Development Services

APPEAL SUMMARY

Appeal ID: 15801	Project Address: 1110 SW Clay St
Hearing Date: 9/13/17	Appellant Name: Marc Abadie
Case No.: B-001	Appellant Phone: 503-847-2180
Appeal Type: Building	Plans Examiner/Inspector: Preliminary
Project Type: commercial	Stories: 16 Occupancy: R-2, A-3, B, S-1, S-2 Construction Type: 1-A
Building/Business Name: Clay + Tiffany	Fire Sprinklers: Yes - throughout
Appeal Involves: Erection of a new structure, Reconsideration of appeal	LUR or Permit Application No.: 17-195442-LU & 17-198428-LU
Plan Submitted Option: pdf [File 1] [File 2]	Proposed use: Affordable Student Housing

PLAN - LEVEL 01

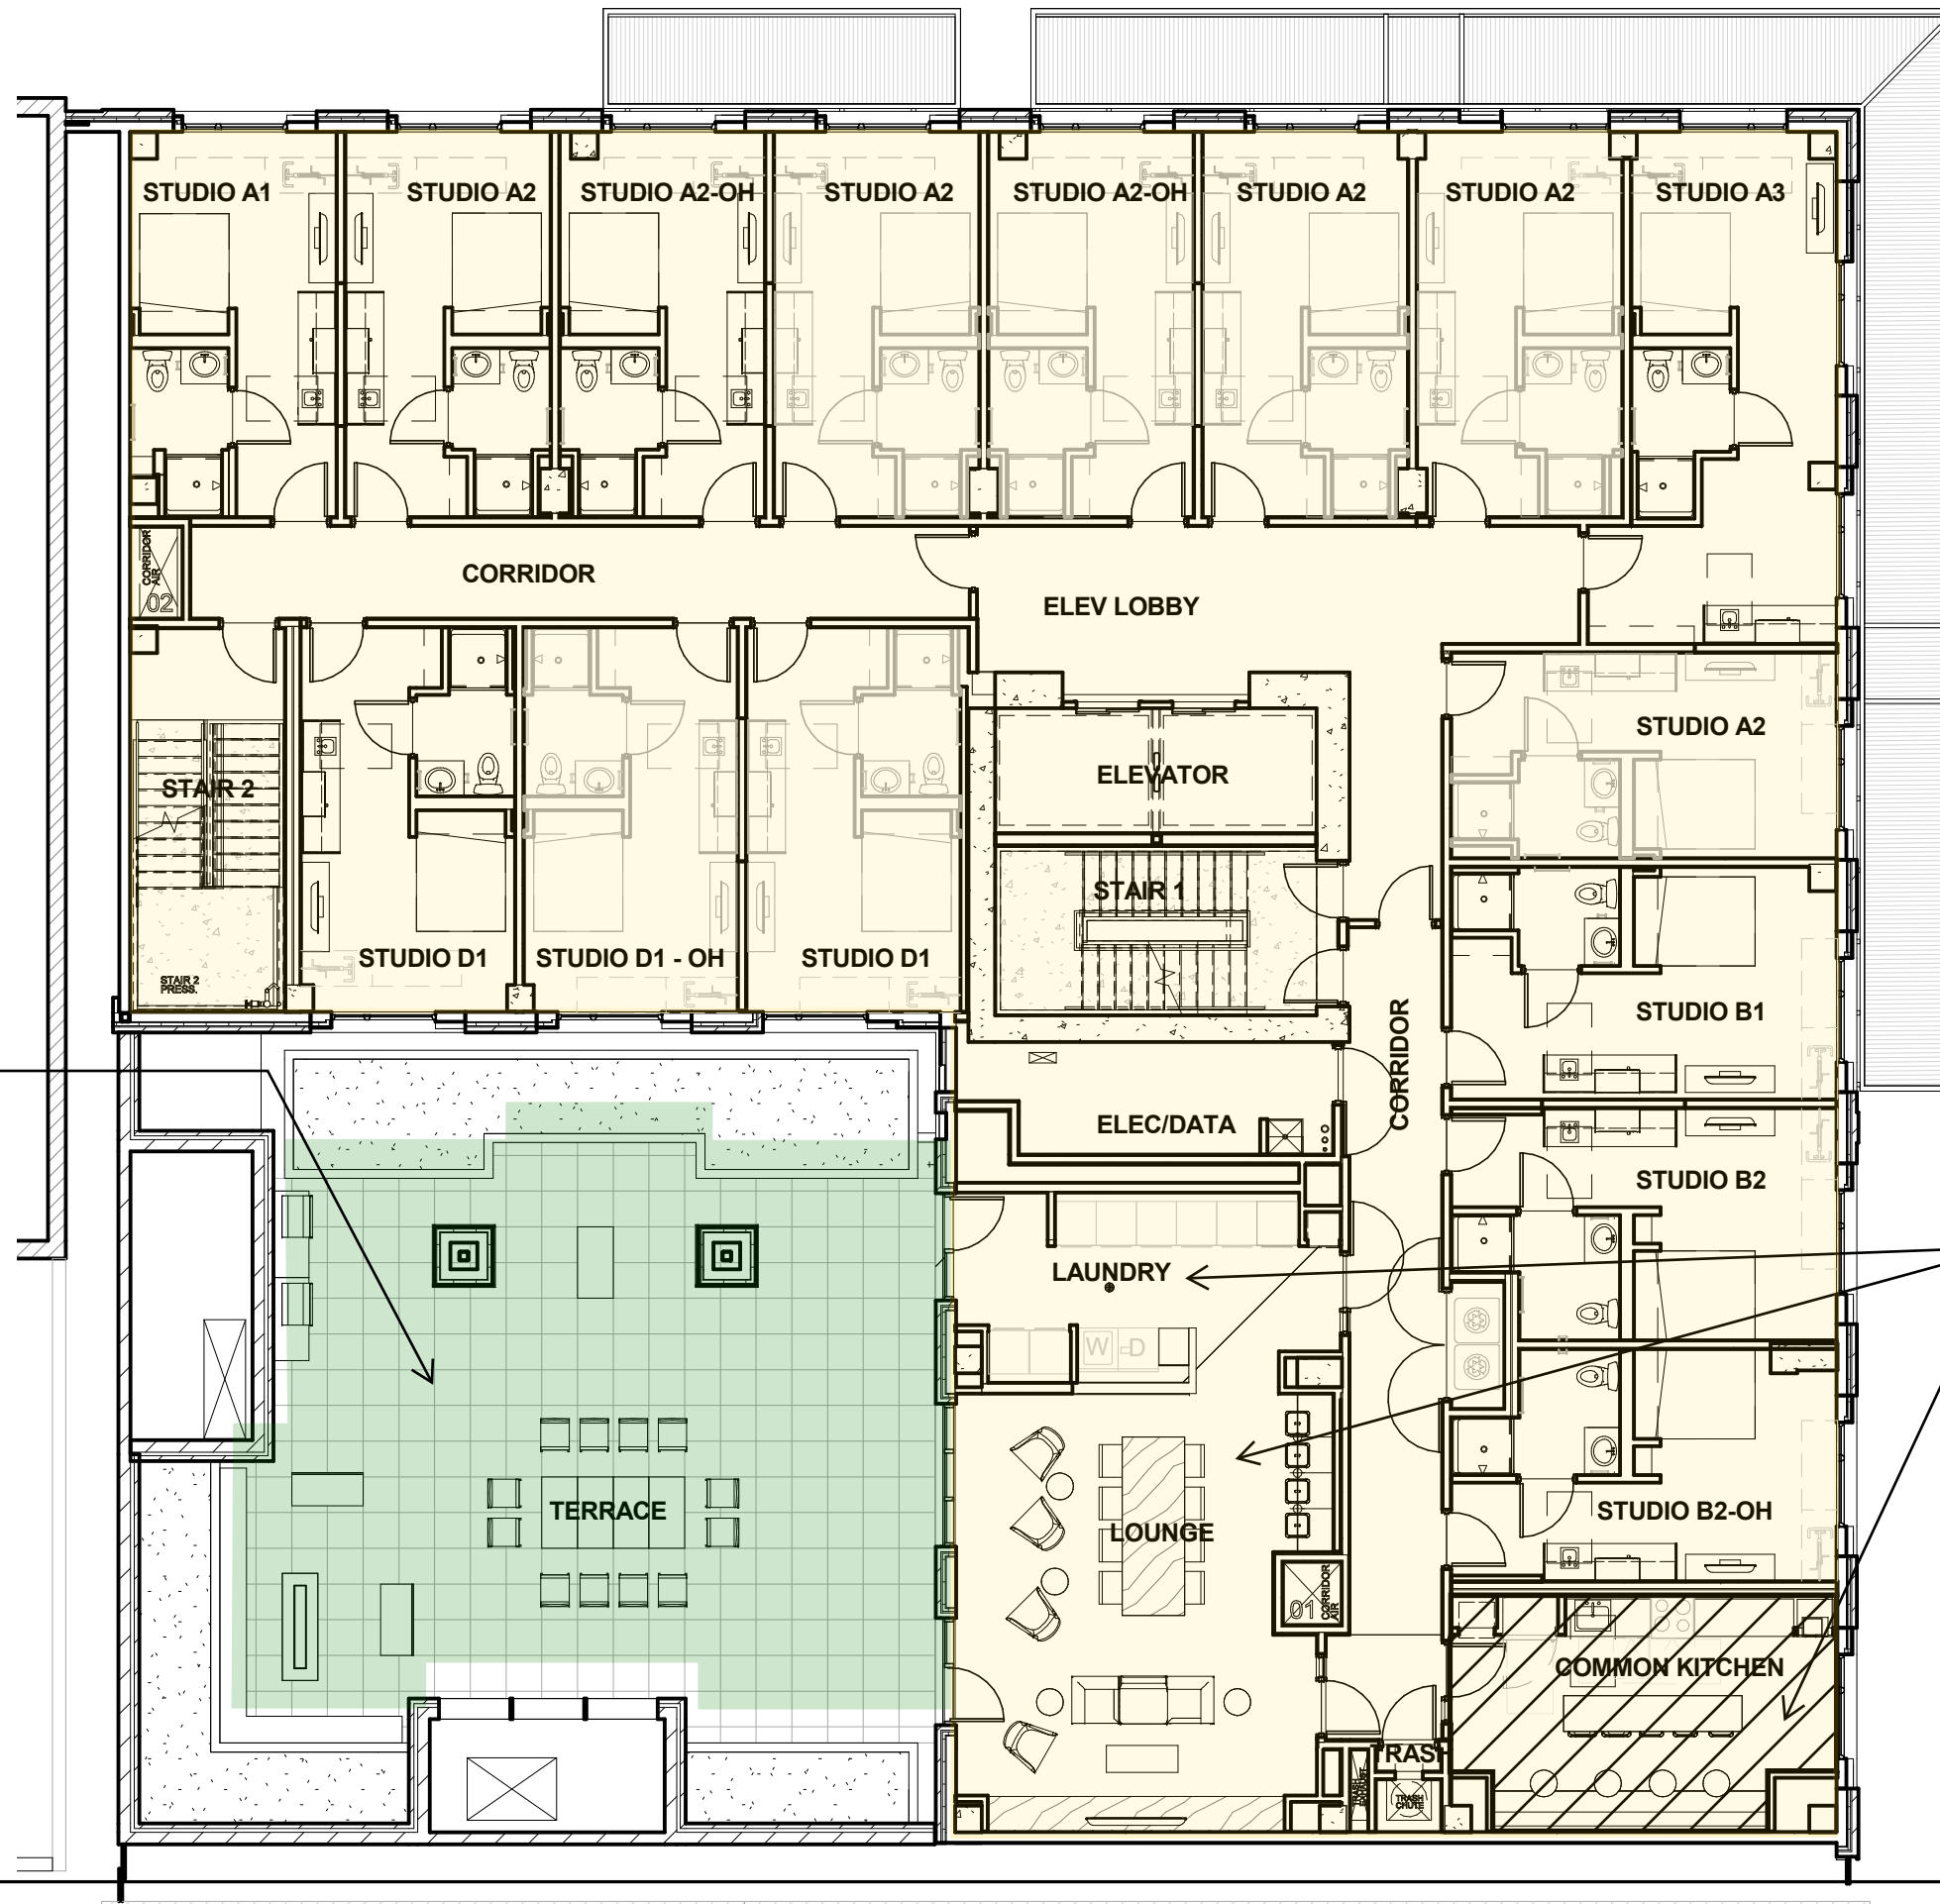
The project consists of two programmatic areas. There is a small commercial-retail space at the north east corner of level 1, accessed only from the street with no connection to the rest of the building. This space has been provided with dedicated unisex toilet rooms to satisfy its required fixture count.

The balance of the building consists of affordable student housing and its support functions. Once entering beyond the leasing office in the lobby the building is closed to the public, intended for tenants and their guests only. (Exhibit 3.2 Plans)

Only areas provided for use other than for the apartment residents and their guests, require public plumbing facilities. Therefore the leasing office area is the only area of the residential portion of the building that requires public toilet facilities for leasing staff, in which a single unisex facility is being provided on Level 1.

TOILET ROOMS DEDICATED TO COMMERCIAL/RETAIL SPACE.

TOILET ROOM DEDICATED TO LEASING FUNCTION (B OCCUPANCY)

1. Reduction in minimum number of plumbing fixtures: Hold for additional information.

PLAN - LEVEL 02

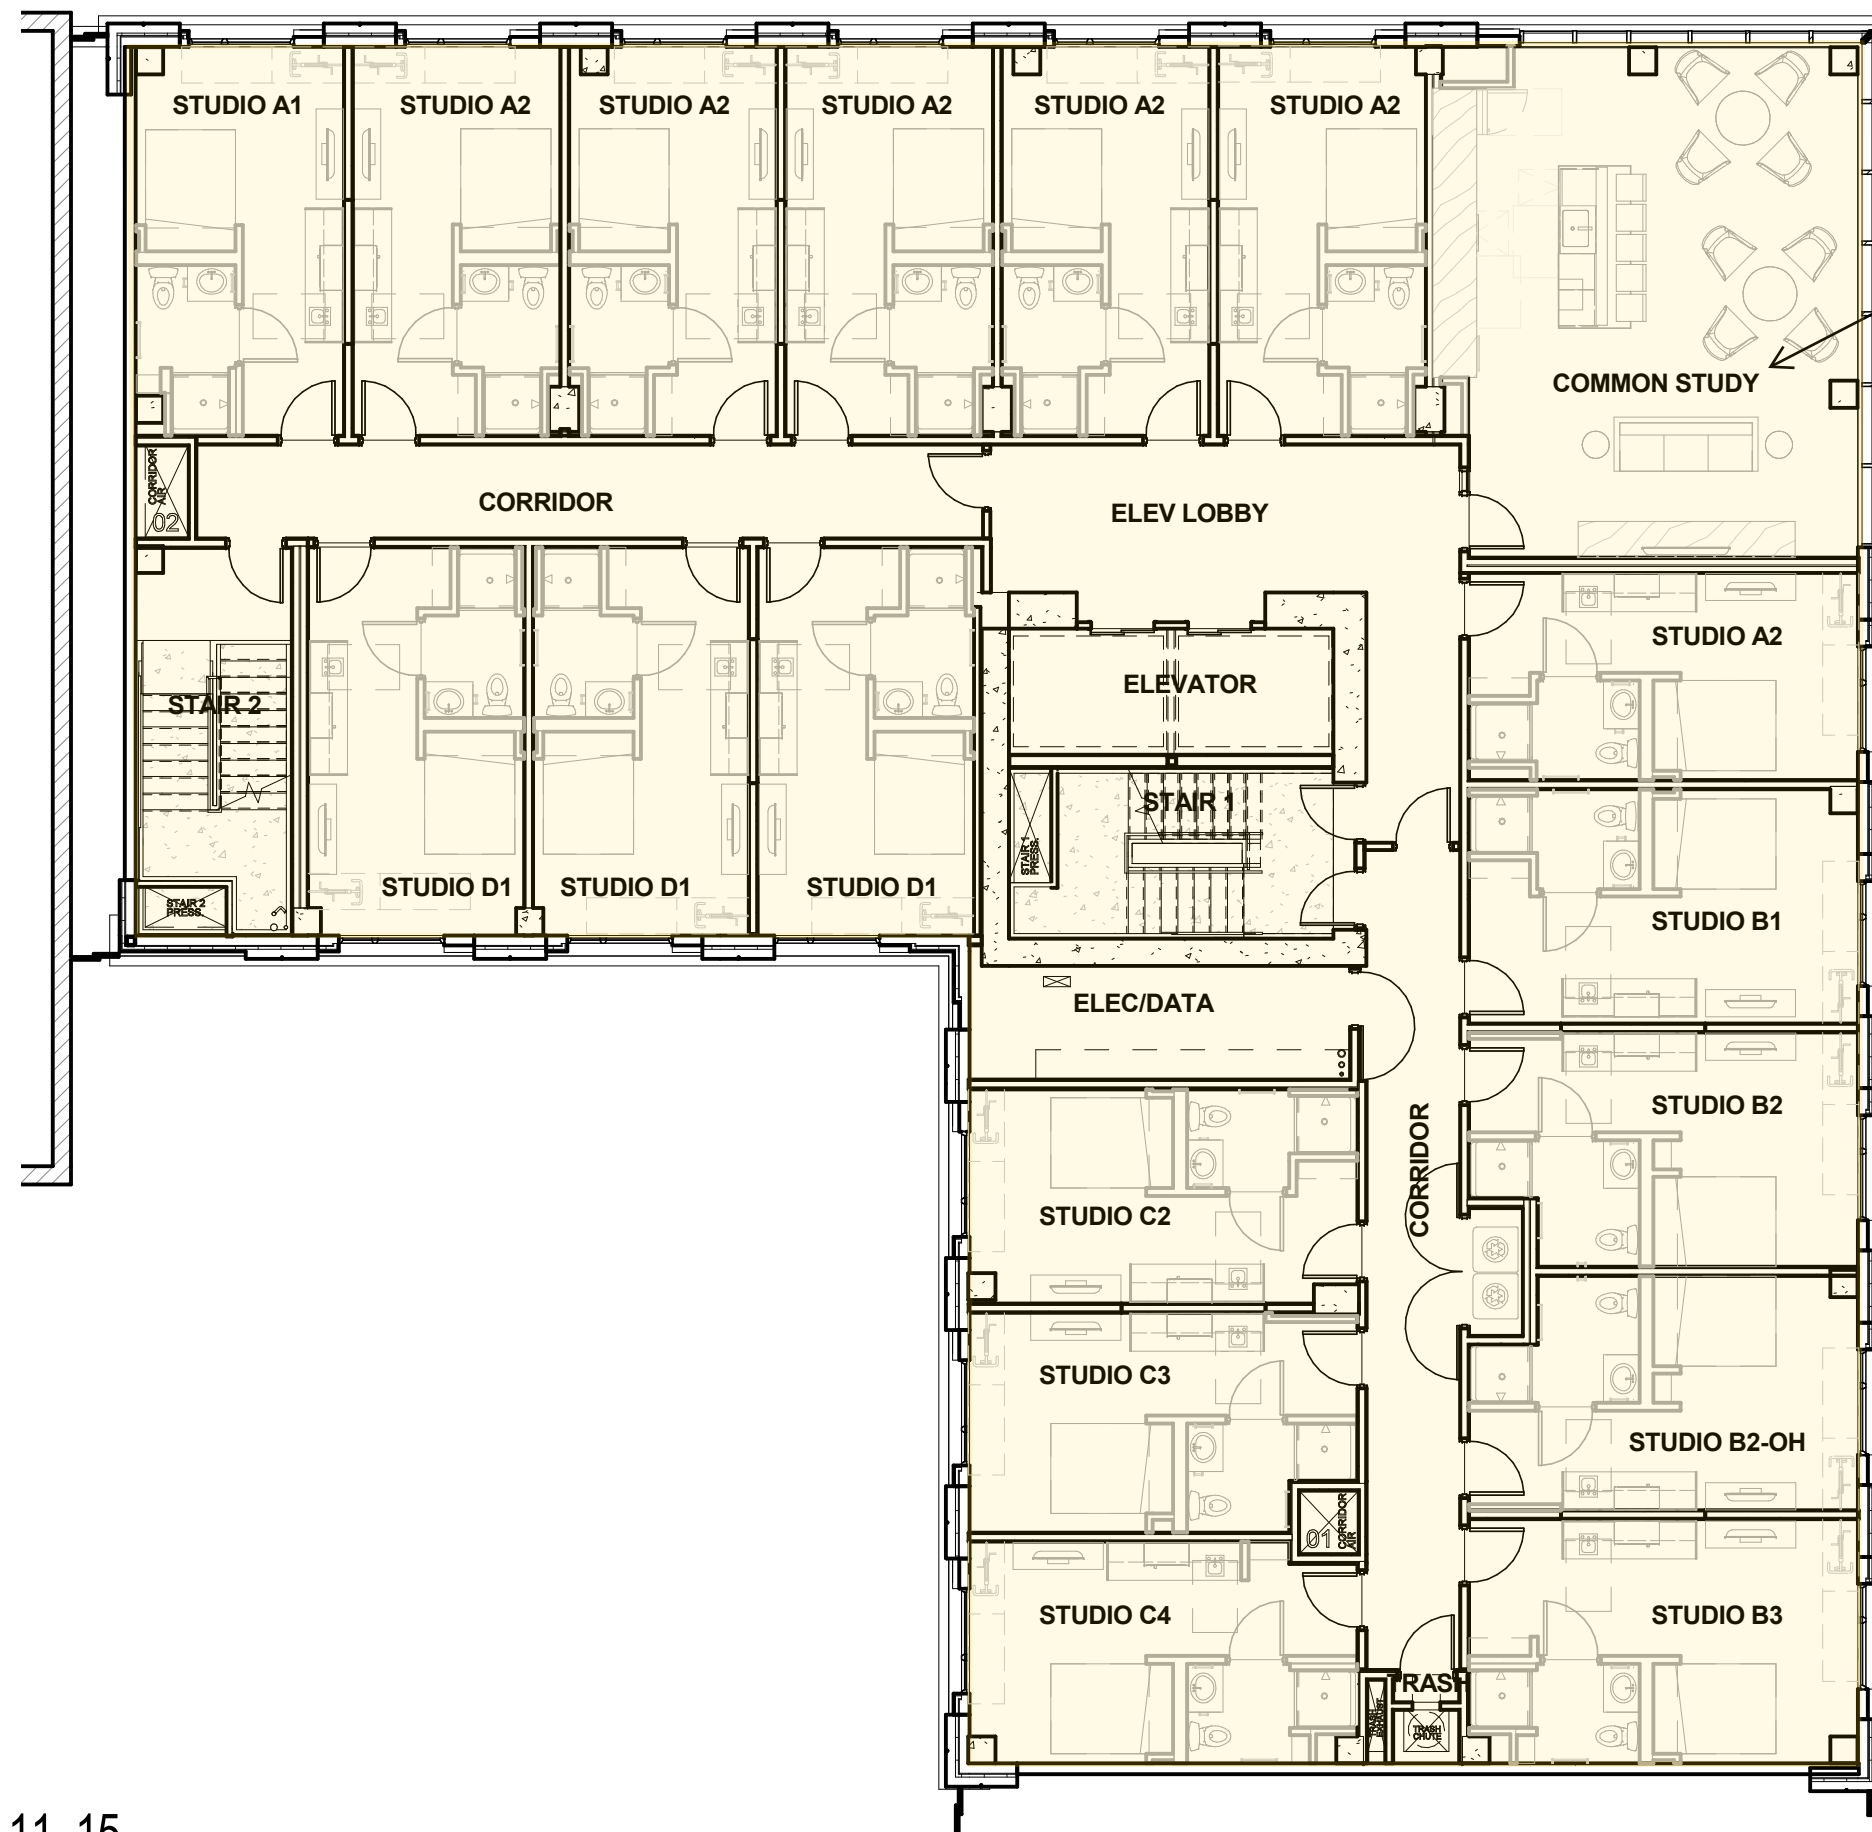
Each apartment contains a toilet room, therefore each tenant has access to a dedicated toilet. As the Level 2 terrace and common areas and the common study lounges are only to be used by the occupants of the private apartment building and their potential guests, these areas would not require additional public plumbing facilities.

COMMON AREA
GREATER THAN 750SF
AND GREATER THAN 50
OCCUPANTS
THEREFORE A-3. TO BE
USED BY TENANTS AND
THEIR GUESTS ONLY.

COMMON AREA LESS
THAN 750SF THEREFORE
R-2

SIDE REACH

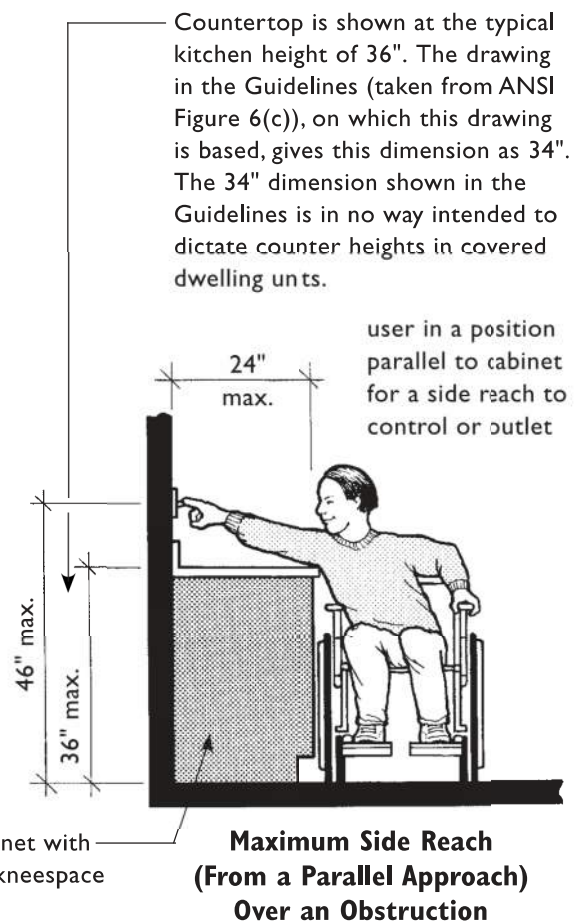
Reason for alternative The 2014 OSSC referenced standard is not consistent with the Fair Housing Act list of safe harbors as ICC A117.1-2009 has not been listed as a safe harbor, see Exhibit C. The proposed design provides industry standard depth countertops (25 ½") as accepted by the Fair Housing Act Design Manual, see Exhibit D, which is recognized as a federal safe harbor. A117.1-2009 is not intended to be used as a stand-alone document. The previous ICC standard (A117.1-2003) was required to be utilized in conjunction with the Fair Housing Act Design Manual.

Cabinet depth is limited to 24 inches.

HUD permits use of a standard 24-inch deep cabinet with an additional extension of 1 to 1-1/2 inches for countertops for a maximum depth of 25-1/2 inches. If a built-in shelf, cabinet, or other obstruction must be deeper than 25-1/2 inches, then any switches, outlets, and controls that must be in accessible locations are not permitted to be installed over such deep surfaces.

2. Accessibility for high reach obstruction to use Fair Housing Act standards: Granted as proposed.
